**ADDENDUM #1**  
**October 19, 2021**

**PROJECT:**     **Center Elementary School Entrance Improvements**

**OWNER:**     City of Waycross

CONVERT CATCH BASIN TO MANHOLE DETAIL  
NTS

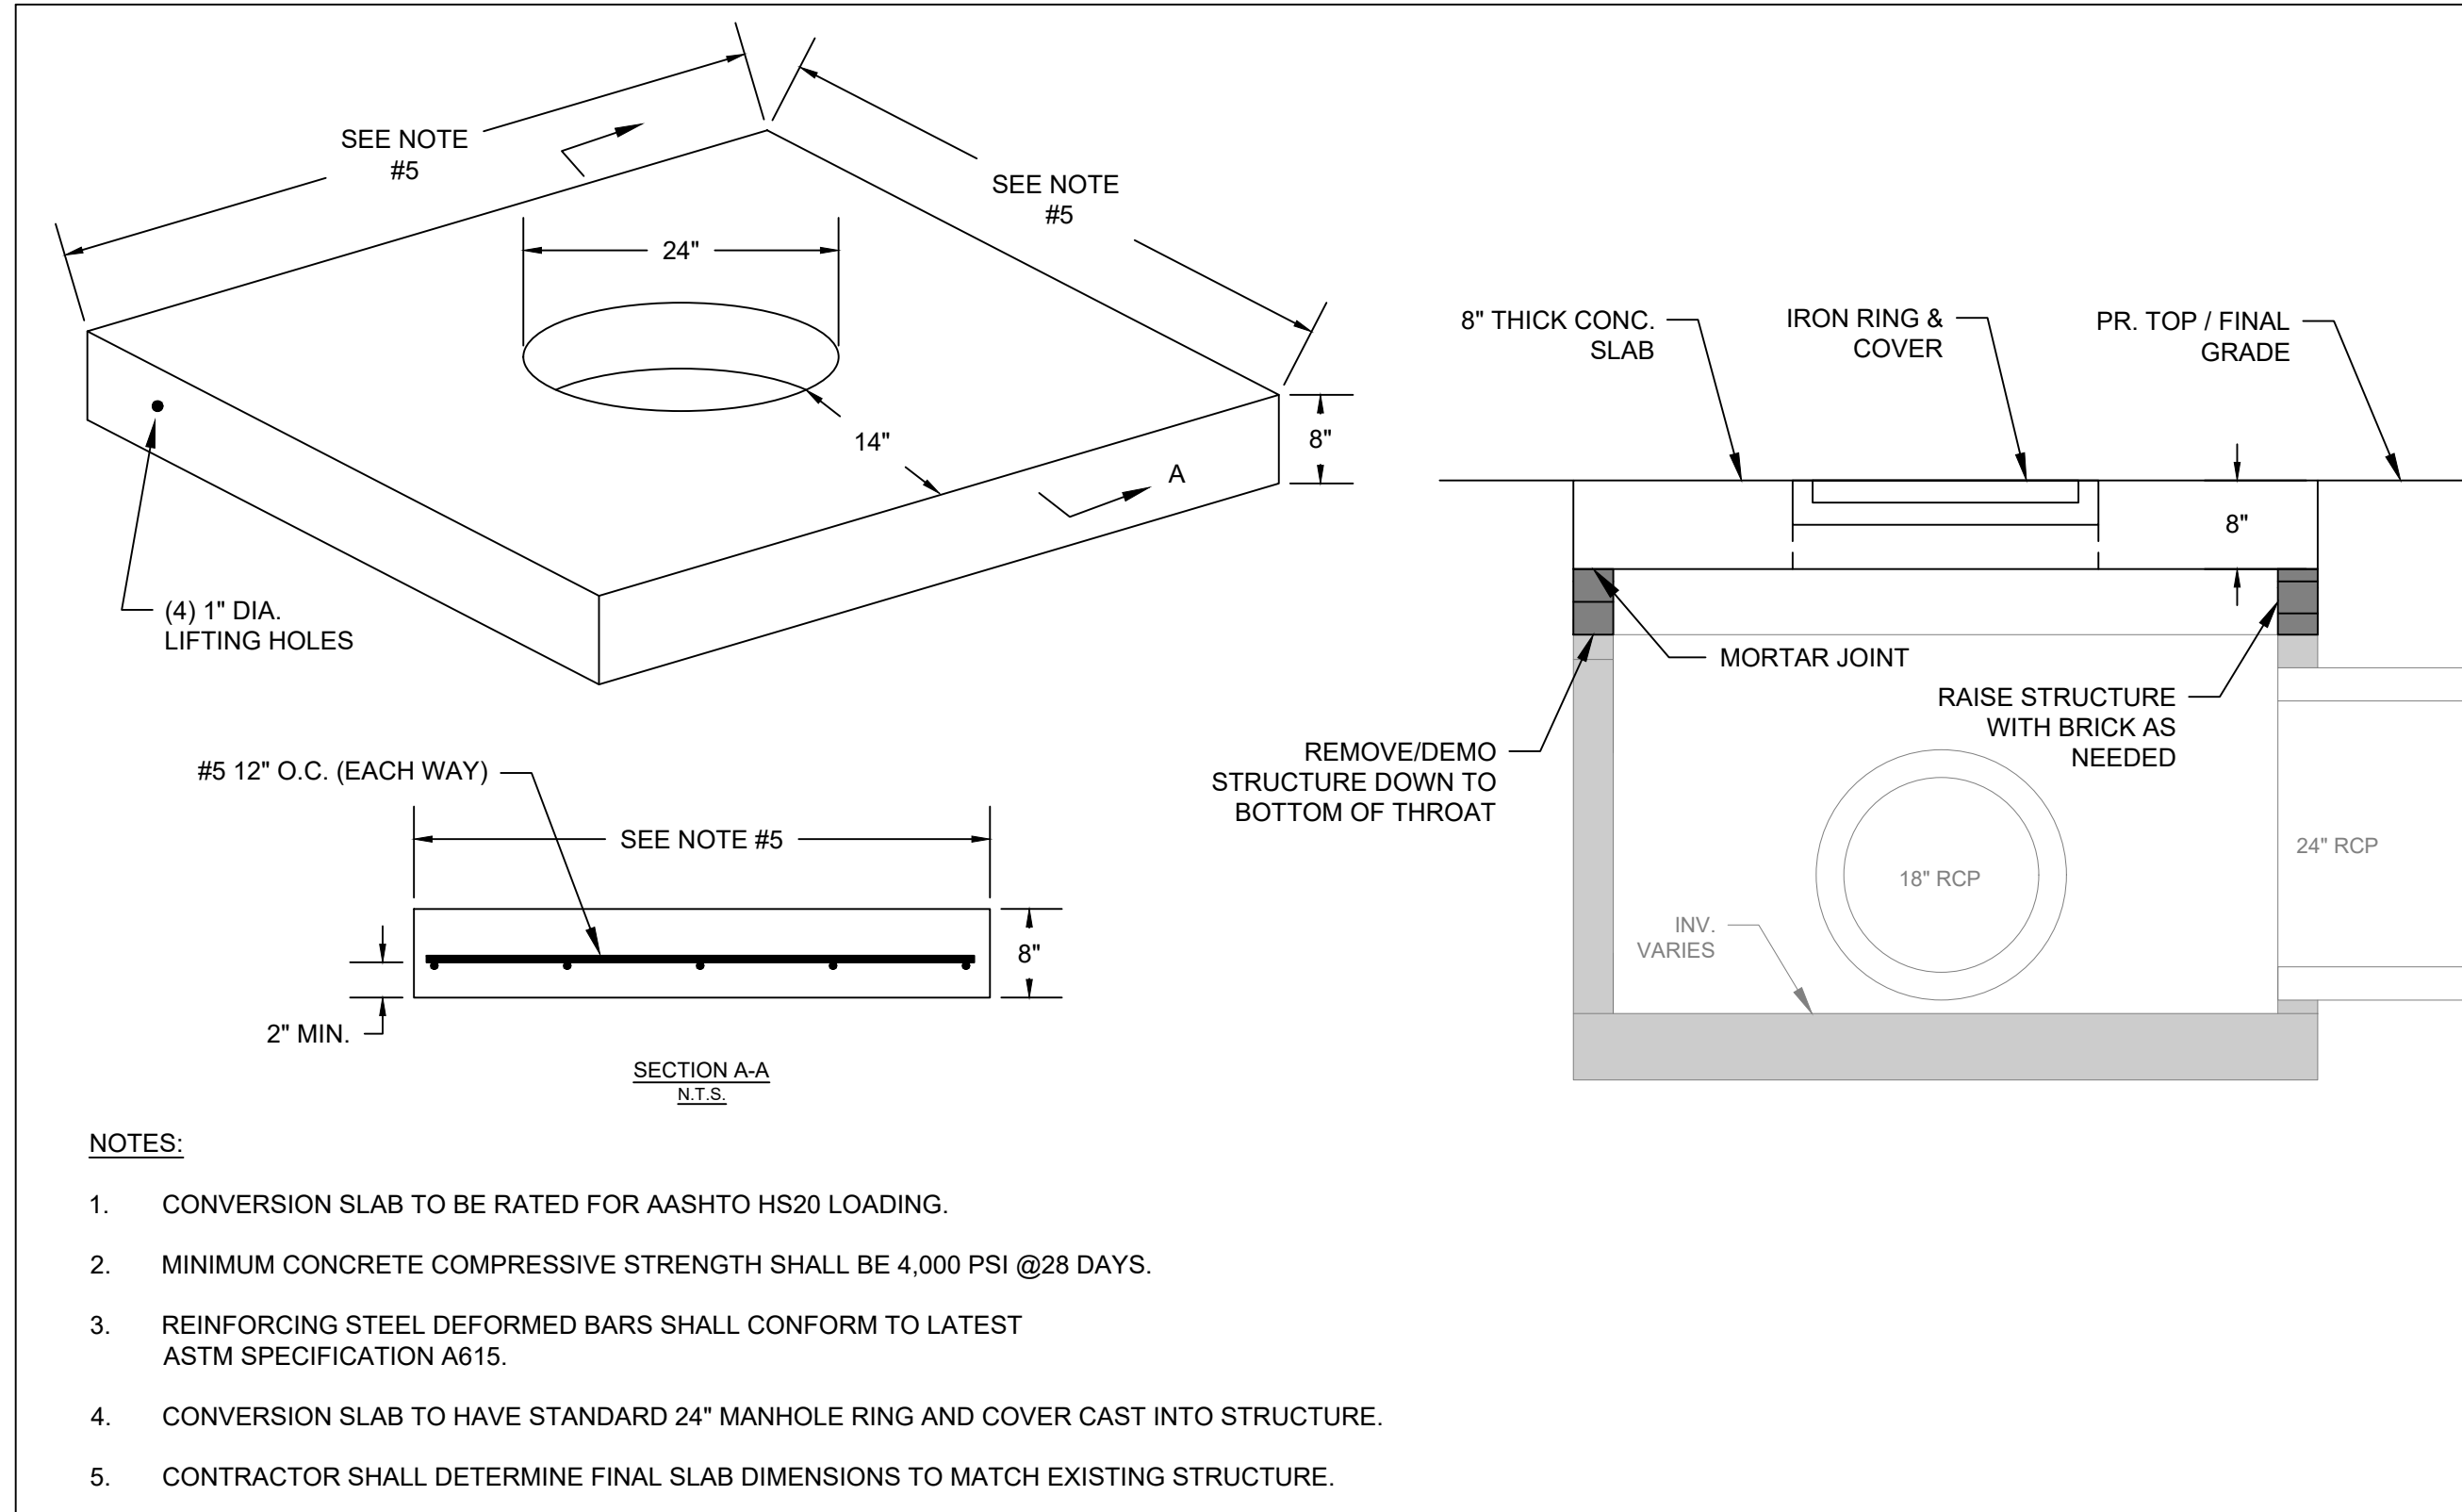
- a. All new storm structures shall be precast structures in accordance with the construction details. A detail for the conversion/modification of existing catch basins to manholes has been included on the details sheet.

REVISIONS	NO.	DESCRIPTION	DATE
1	ADDENDUM #1 - ADDED CATCH BASIN CONVERSION DETAIL	10/19/21
